MEDFORD SCHOOL DISTRICT 549C
JACKSON ELEMENTARY SCHOOL
EXPANDED TRACK FACILITY
MAP 37-2W-24CD, TAX LOT 6400
715 SUMMIT AVE., MEDFORD, OR. 97501

PLAN VIEW - CIVIL SITE PLAN

NO.	REVISION DESCRIPTION	DATE
1	ADDENDUM #1	03/20/26
2		
3		
4		
5		
6		
7		
8		
9		
10		
11		
12		
13		
14		
15		
16		
17		
18		
19		
20		
21		
22		
23		
24		
25		
26		
27		
28		
29		
30		
31		
32		
33		
34		
35		
36		
37		
38		
39		
40		
41		
42		
43		
44		
45		
46		
47		
48		
49		
50		
51		
52		
53		
54		
55		
56		
57		
58		
59		
60		
61		
62		
63		
64		
65		
66		
67		
68		
69		
70		
71		
72		
73		
74		
75		
76		
77		
78		
79		
80		
81		
82		
83		
84		
85		
86		
87		
88		
89		
90		
91		
92		
93		
94		
95		
96		
97		
98		
99		
100

DRAWN BY:	TDP
DESIGNED BY:	TDP
CHECKED BY:	TDP
ISSUE DATE:	03/20/26
BID SET	
JOB NO.	25-036
CIVIL SITE PLAN	
C3.0

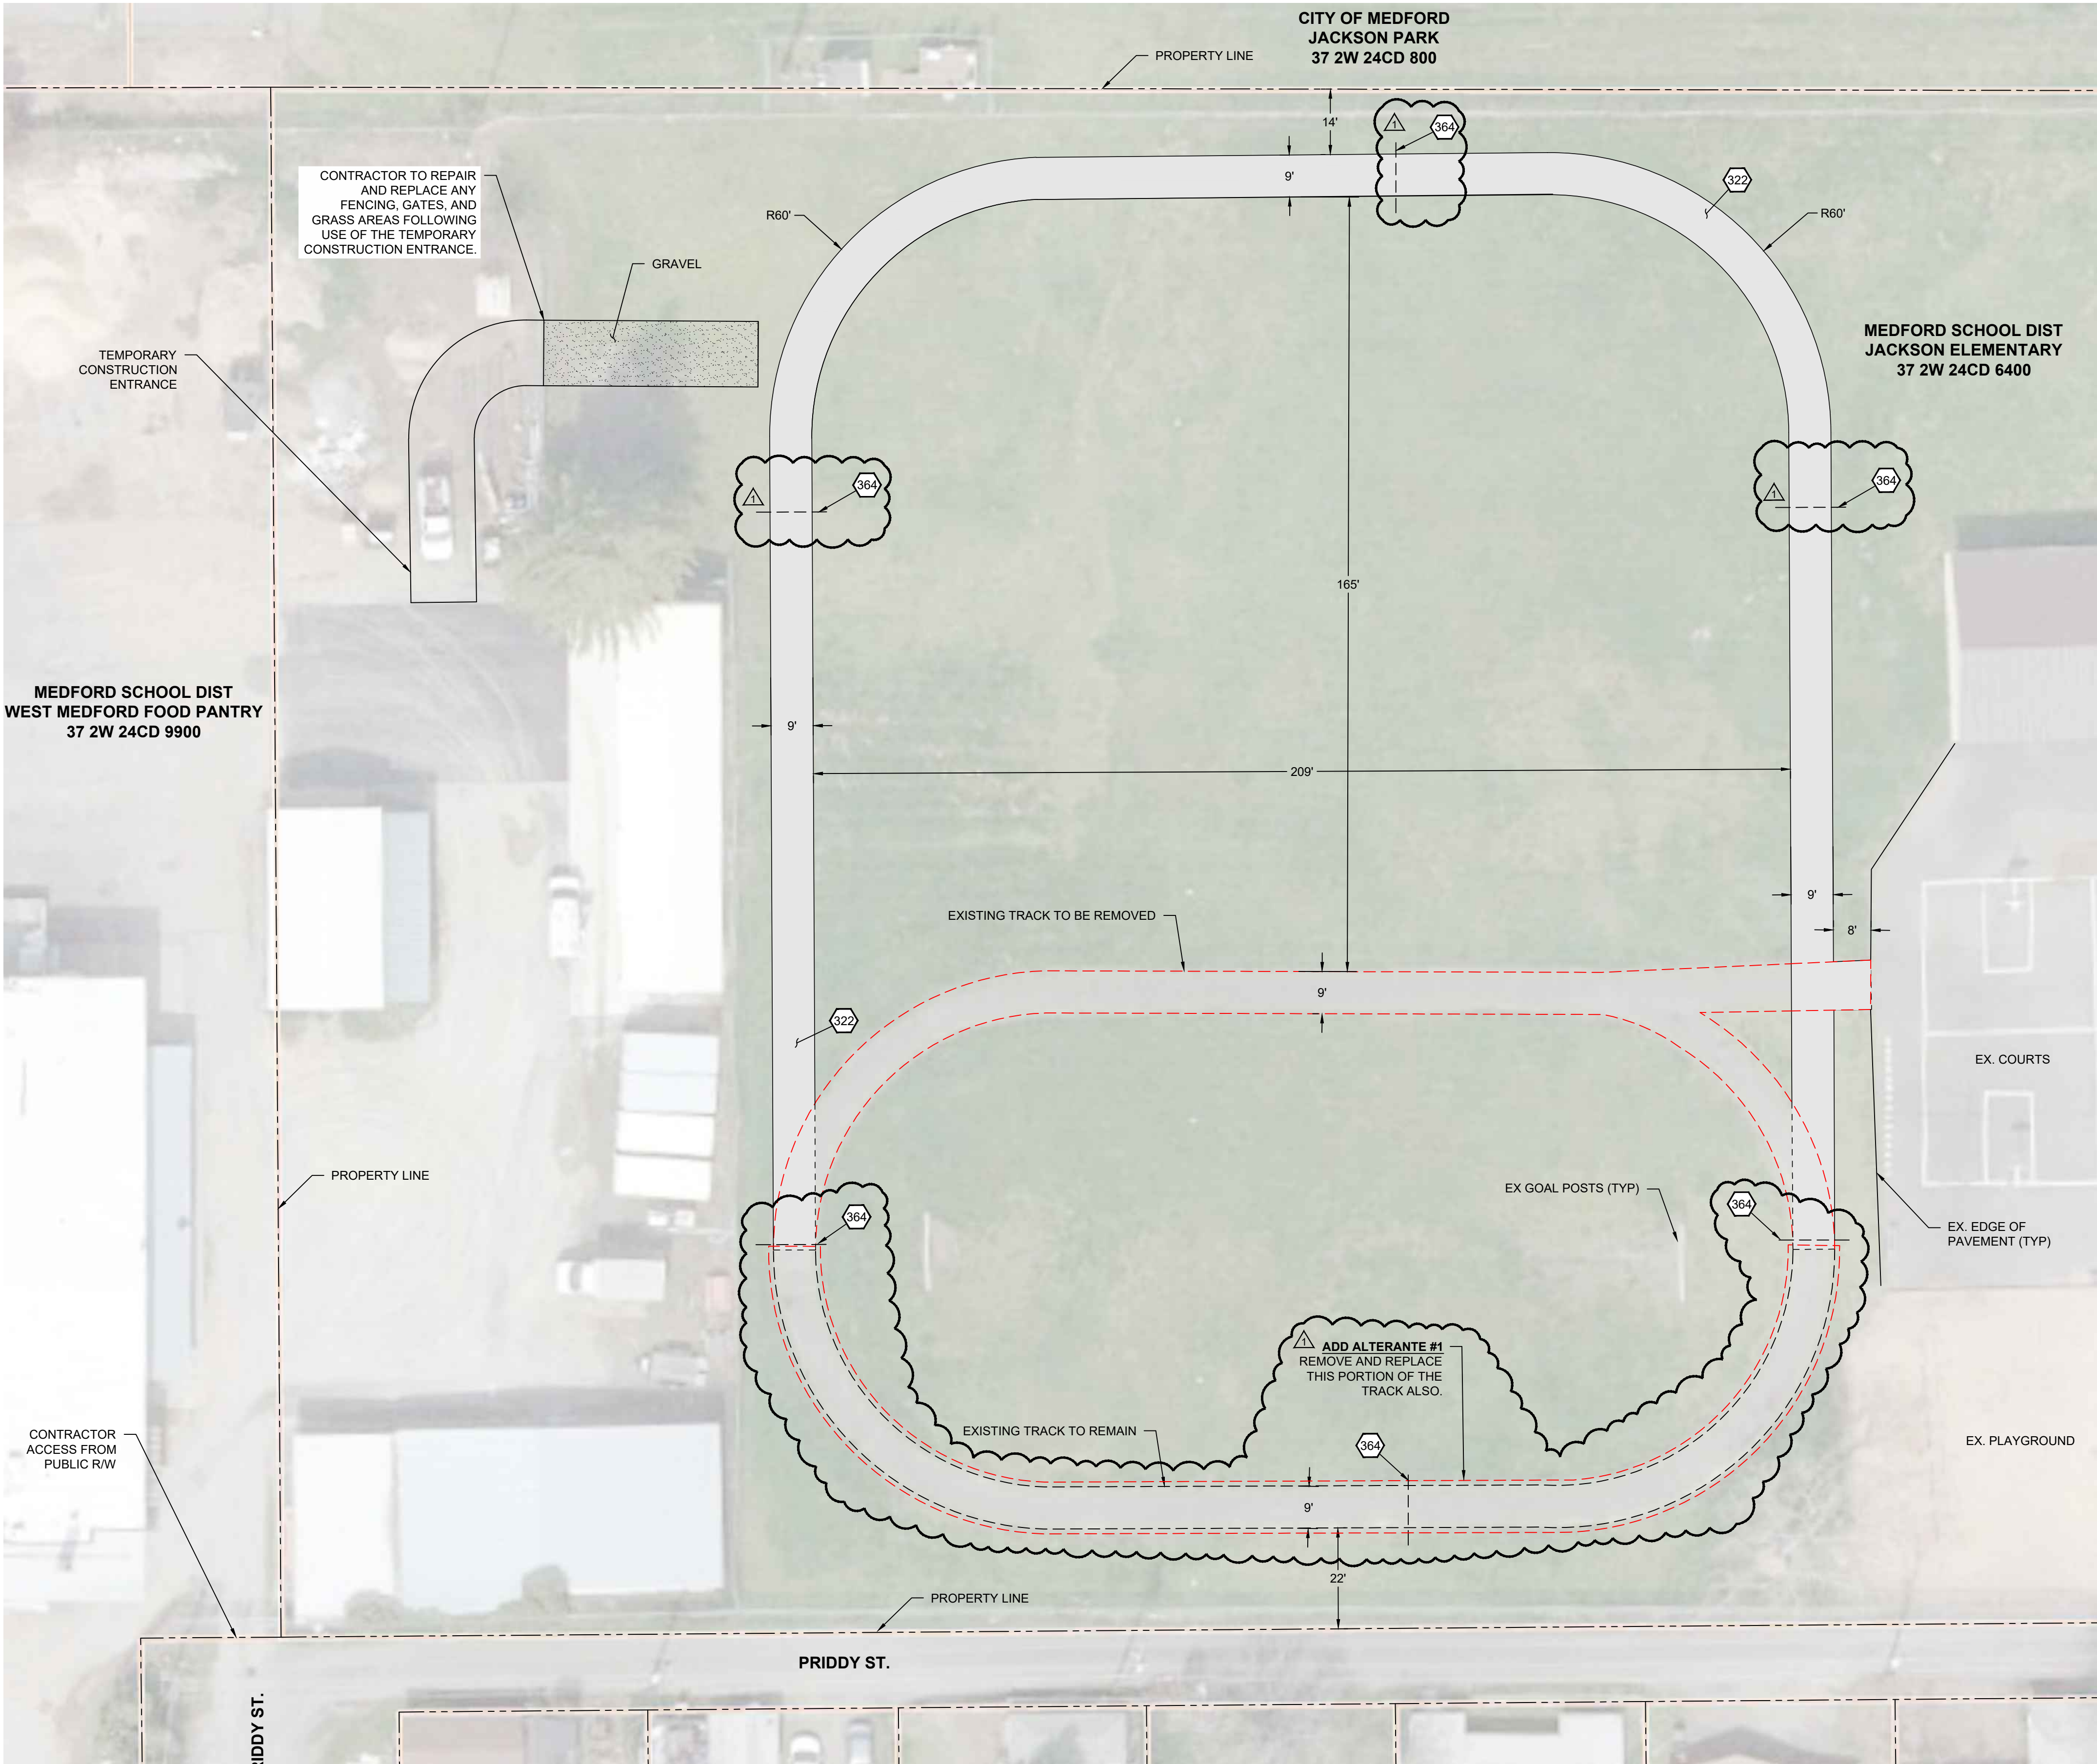
1. ADD REMOVE AND REPLACE OF SOUTHERN HALF OF TRACK.
2. ADD WHITE LANE STRIPING AT 27" INTERVALS TO COMPLETE 4 TRACK LANES

- ADD 2" WHITE LANE STRIPING AT 27" O.C. INTERVALS TO COMPLETE 4 TRACK LANES
